Campaign No. 2024040003, April 2024

SUBJECT: **Model GLC (254 platform)**
Model Year 2023

Check Coolant Valve

Figure 1: Coolant directional control valve (Y73/1) of low-temperature circuit (**1**)

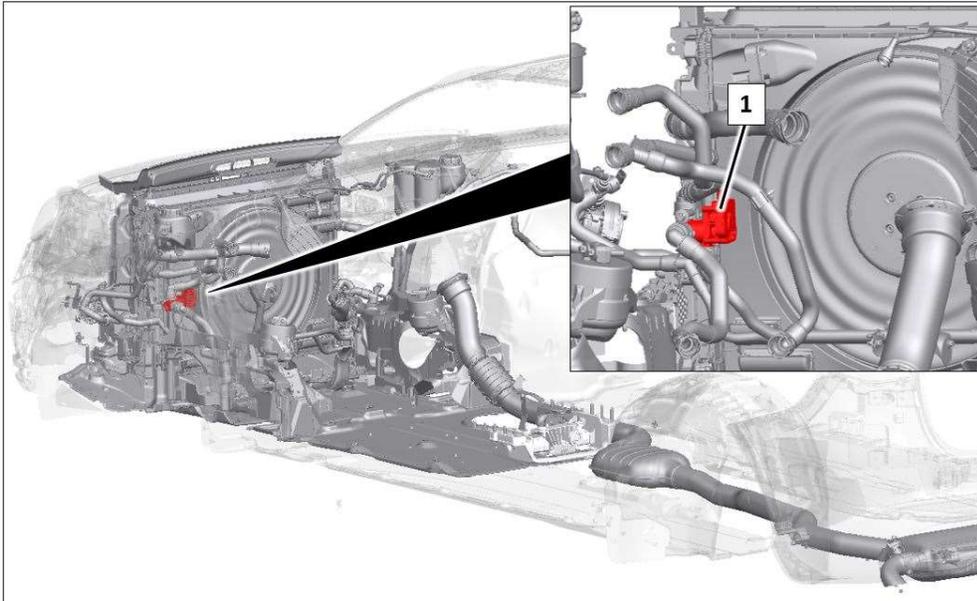
Mercedes-Benz AG, the manufacturer of Mercedes-Benz vehicles, has determined that on certain MY 23 GLC (254 platform) vehicles, the regulation valve in the low-temperature coolant circuit may become stuck. This would lead to a fault message in the instrument cluster. An authorized Mercedes-Benz dealer will check the coolant valve on the affected vehicles and replace it, if necessary.

1. Replace **coolant directional control valve (Y73/1)** of low-temperature circuit (**Figure 1, 1**).
i For basic information, see **AR09.41-P-0131MRV**.
